901 Lenora

Recommendation Meeting

#3039979-LU

11/21/2023

South Facade | Facade Grid Diagram

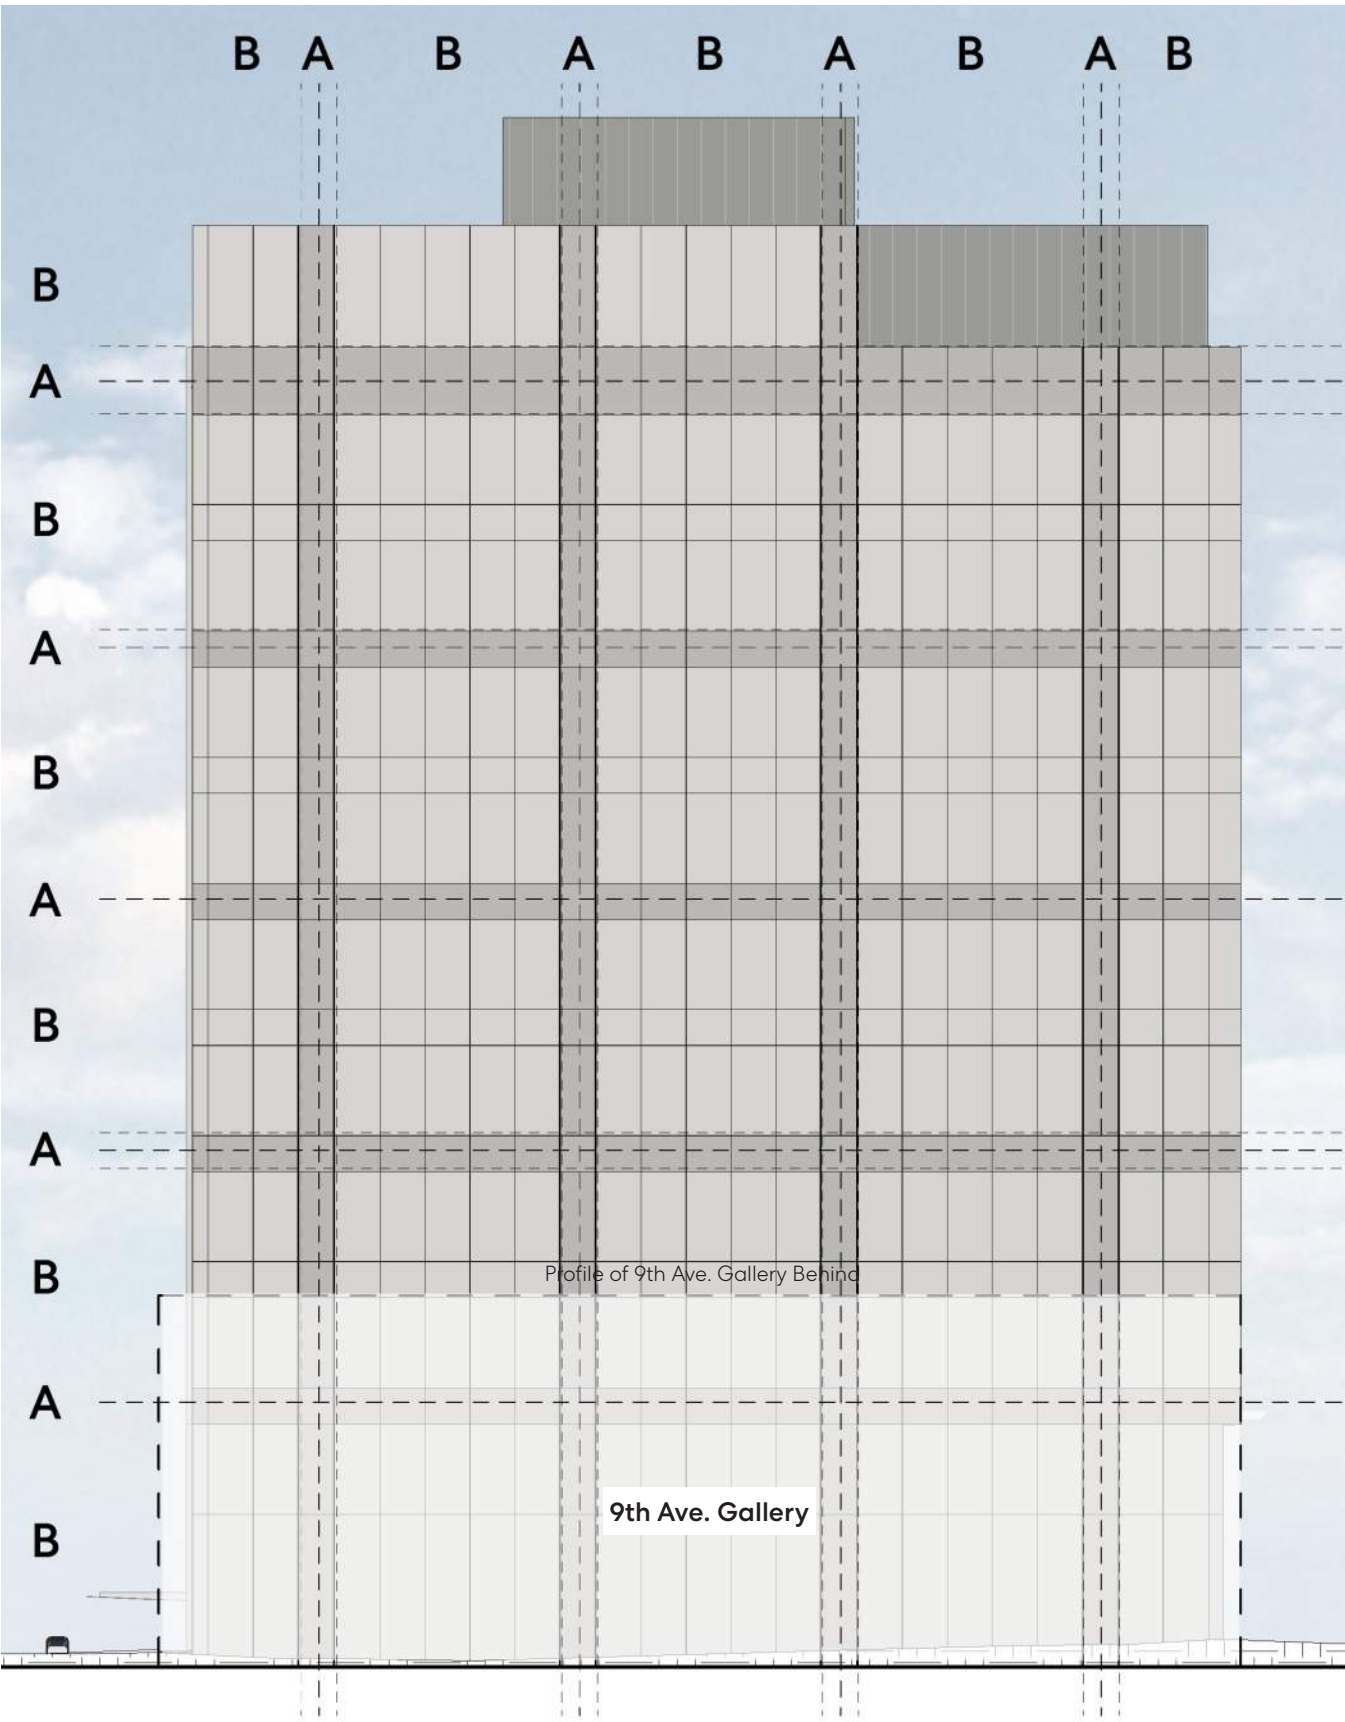
1d. The Board provided direction to **pay special attention to the articulation of the south façade** and clarify at the Recommendation meeting **how the proposal responds to the existing structure and possible future development.** (C-2, A-1)

1d. In response to the Board’s comments, the pattern of the south facade has also taken inspiration from the 9th Ave Gallery immediately south of our site. Similar to the street facing facade of the Gallery, the proposed south facade incorporates an A-B pattern of thinner vertical lines (A) and wider cells (B). Careful attention has been made to center this grid on the south facade, similar to the pattern present on the 9th Ave Gallery facade.

1. Massing Options - Neighborhood Datums

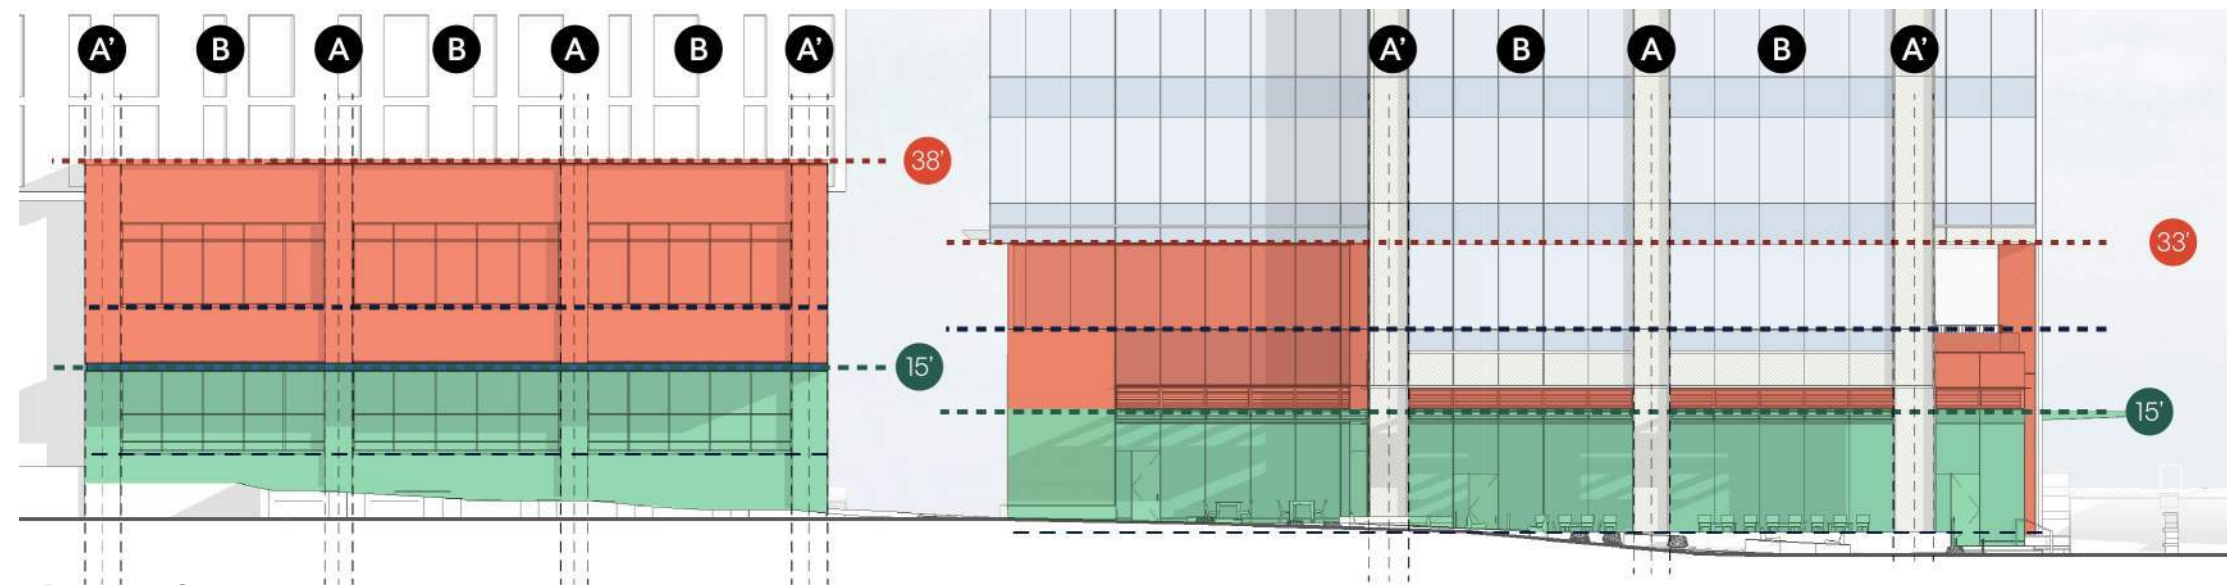
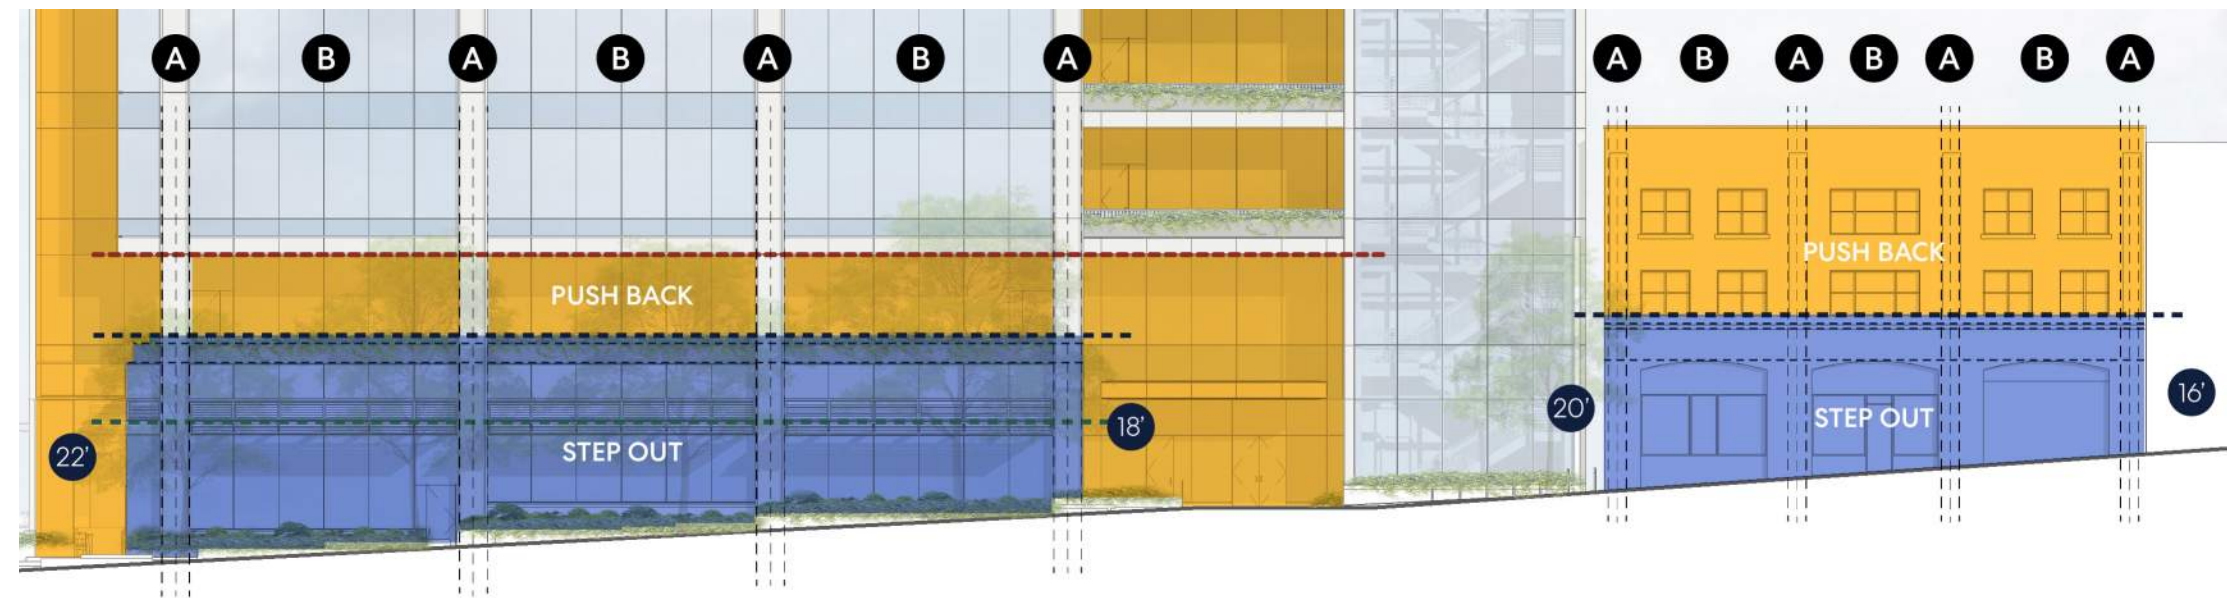
1f. The Board appreciated the detailed study of datum line response. However, at the Recommendation phase the Board would like to **better understand the datum relationship with the buildings to the immediate southeast and northeast.**
(C-2, A-1)

1f. The design team appreciates the Board's acknowledgment of the datum line diagrams shared at EDG and appreciates the opportunity to provide further insight into our relationship with the buildings to the immediate southeast and northeast. In response, further diagrams have been developed to describe the following relationships:

The proposed design relates to the Lenora St datum set by the Cornish Commons building at two key levels. First, the proposed canopy and L01 glass head height is located at a similar height (15') above grade, continuing the perceived visual canopy created by overhead weather protection at Cornish Commons.

Second, the proposed design strikes a clear datum line at the L03 soffit, where the alley facade steps out 2' and the L02 terrace steps back out along 9th Ave. This datum is struck at a comparable height to the podium parapet on Cornish Commons, visually communicating the separation between the public realm and tower above, while maintaining key open space at grade.

EDG Supported | Departure Diagram 3D

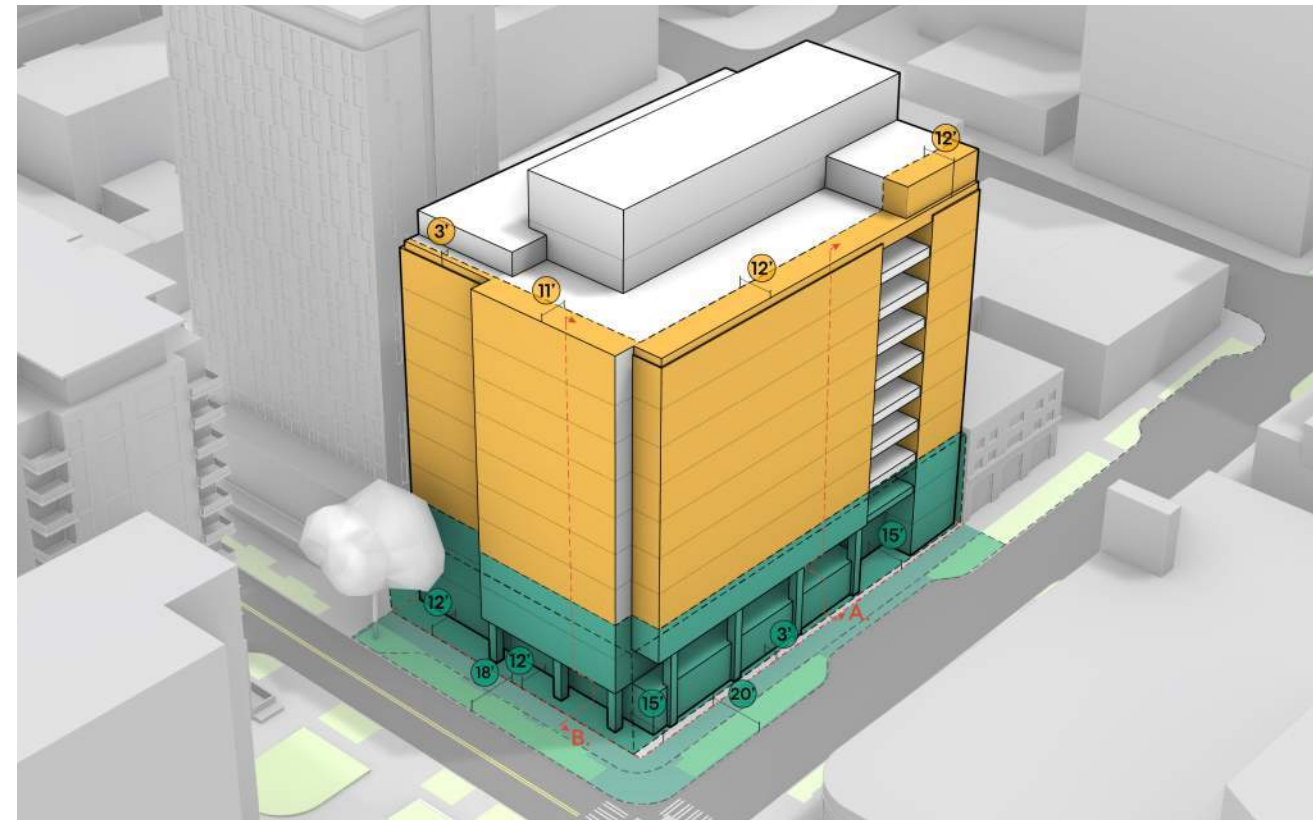
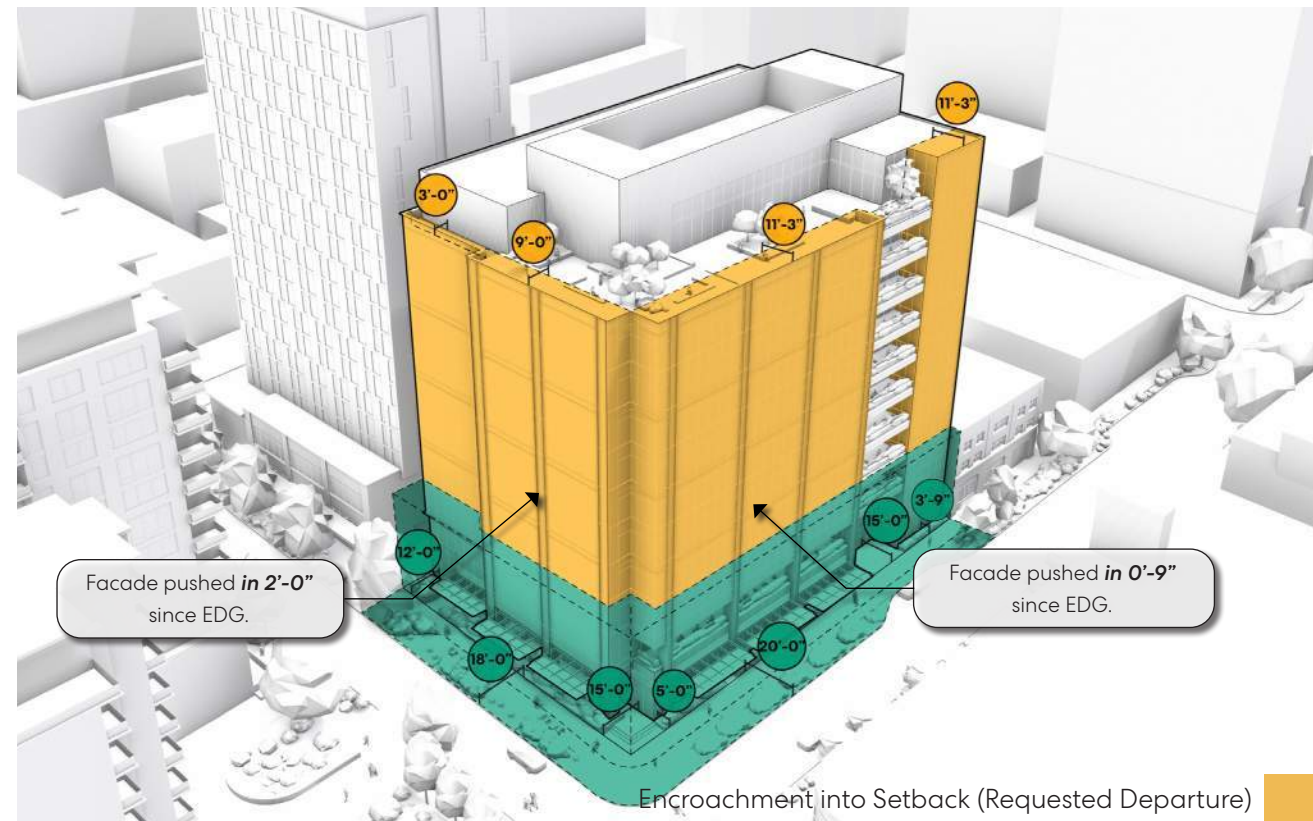
3a. The Board discussed the departures required for Option C as summarized below. While **supportive of the preferred massing option**, the Board was concerned about the magnitude of the departures requested and how it could impact the character of Lenora St and 9th Ave as designated green streets. Therefore, the Board requested **further study and analysis be provided at the Recommendation phase demonstrating impacts to light, air, and views in the immediate context**. The packet should include broader perspective views of the impacted street corridors to **better understand how the structure will encroach within the required setbacks and impact the overall experience of the two streets**. (B-1, C-1, C-2, D-1)

3a. The design team appreciates the Board’s request for further analysis of the impacts of the building massing on the public realm. In response, the team has refined the building massing to reduce the total magnitude of the departure and has also provided analysis of the comparative impact on daylight in the pubic realm between the preferred Opt C massing, and the code compliant Opt A massing. Below is a summary of the refinements to the massing and the comparative daylight metrics:

Potential Signage Locations | Perspective View from NW Corner

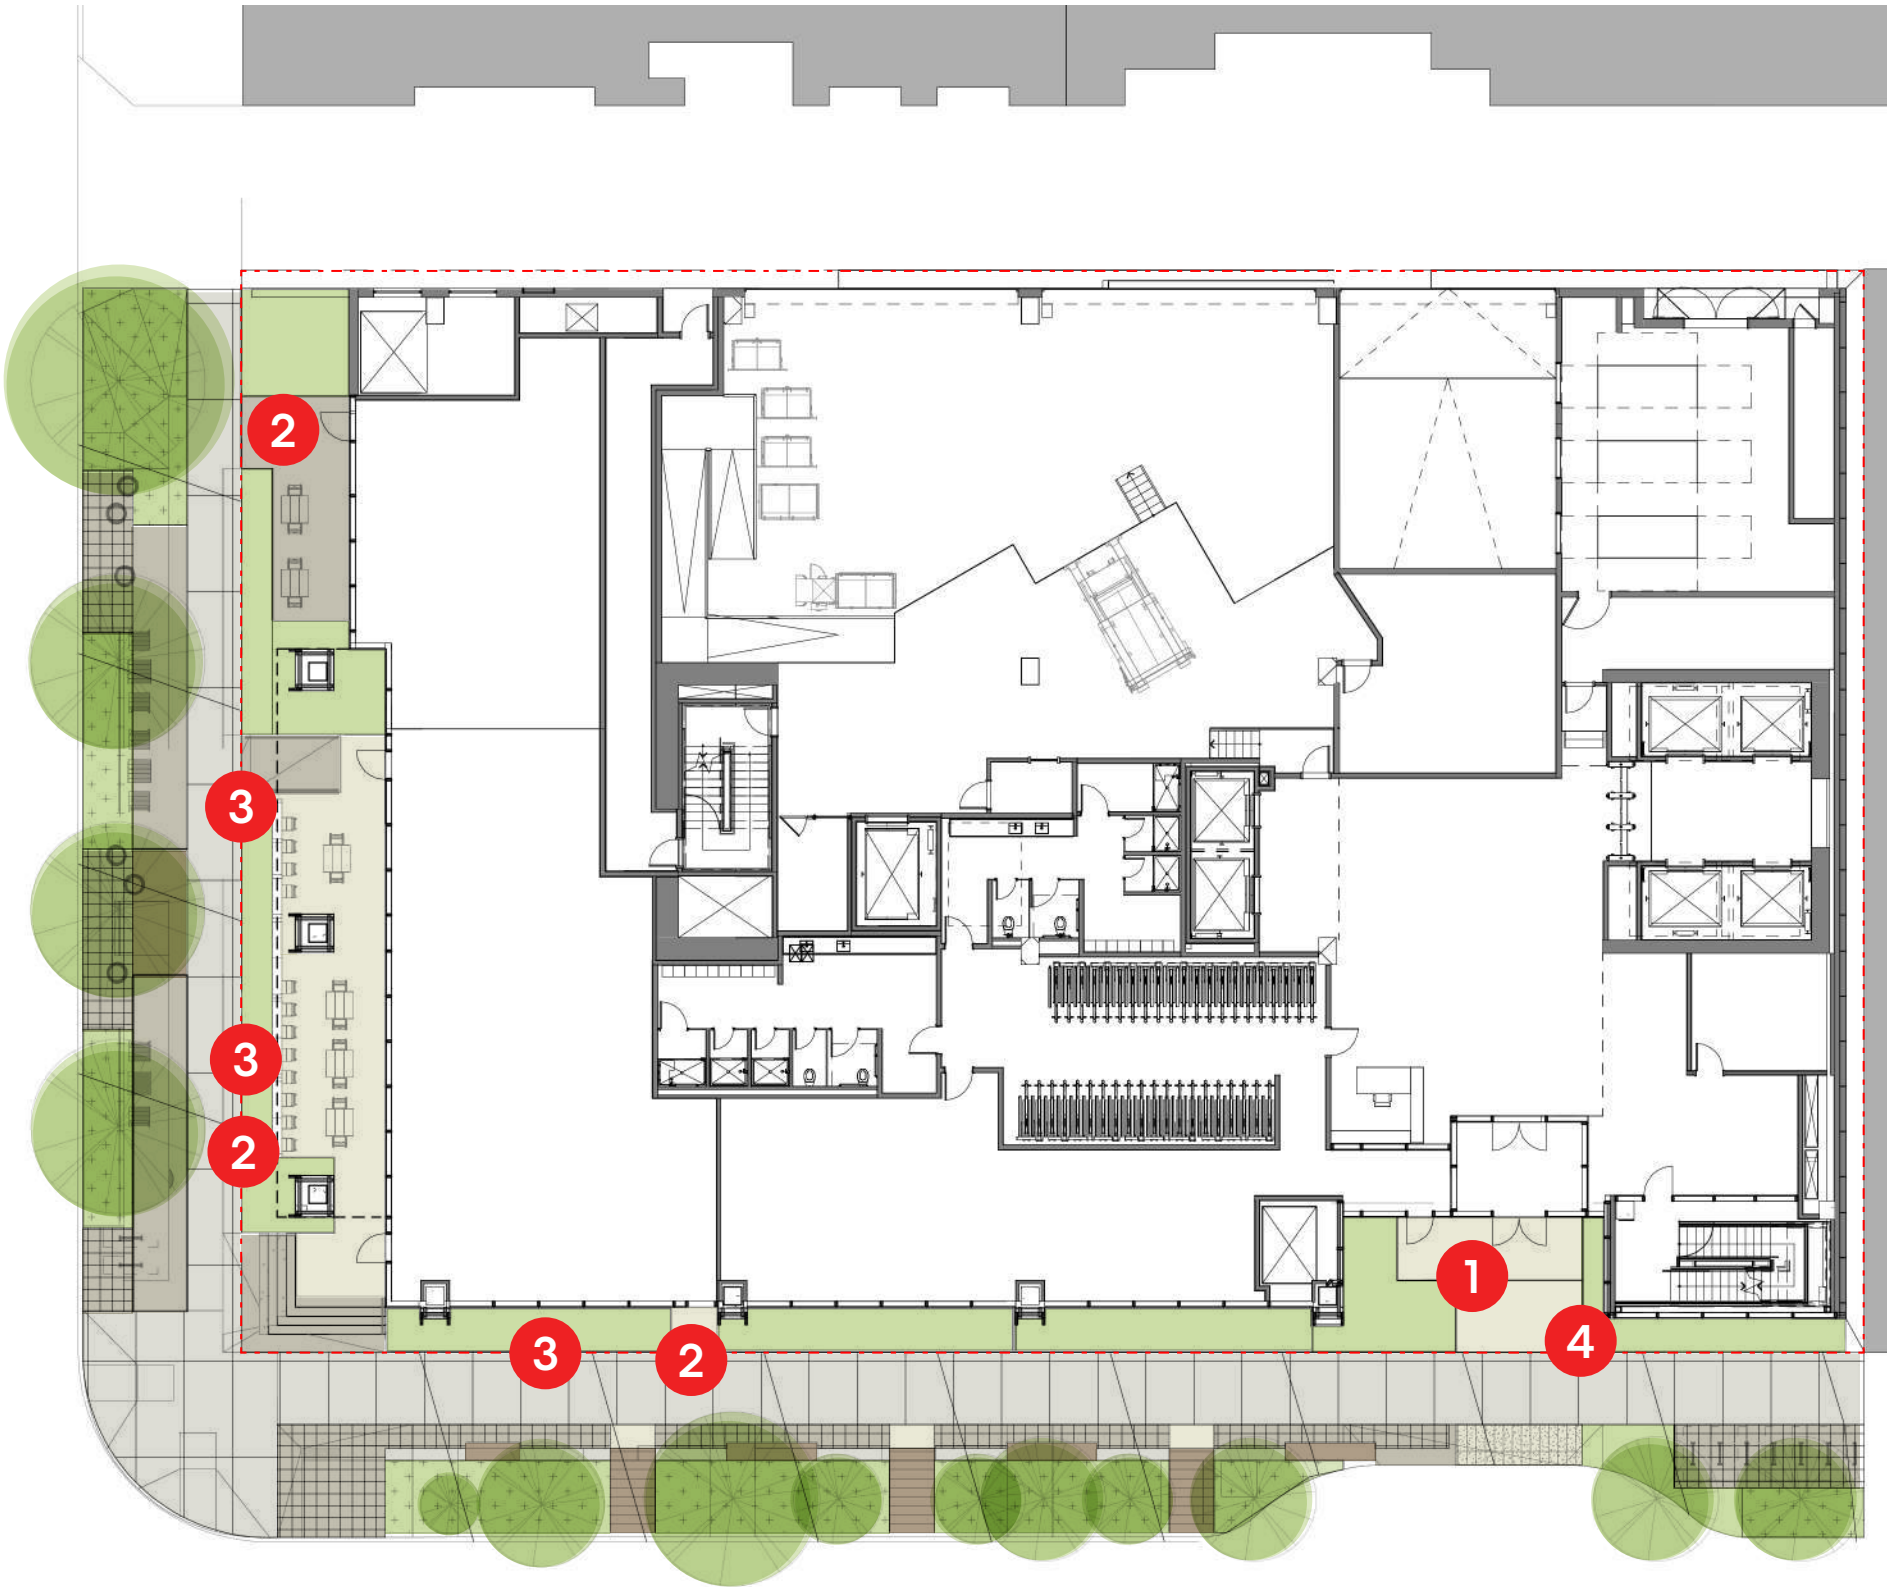
4a. At the Recommendation phase the Board expects to see **fully developed signage and lighting plans.** (D-4, D-5)

4a. Developed signage plans have been included in the packet as requested by the board. Signage will be focused to the ground level and primarily serve the retail uses along both frontages, with a modest building identity signage located at the main building entry.
